UNITED STATES DEPARTMENT OF COMMERCE
Patent and Trademark Office

09/558,694 04/25/00 GILBERT

Office Action Summary

DETAILED ACTION

FIGURE 1

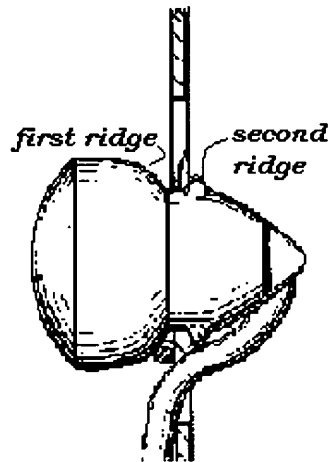
Blair discloses a charge holder (10) for accepting a case (12), the charge holder comprising a loading member including at least one hole disposed through a wall of the loading member (seen in figure 2), the hole having a circumference defining at least one tab (see detail below).

Regarding claim 3, Blair discloses a first and second ridge defining a groove between wherein the tab can be captured within the groove (see detail below).
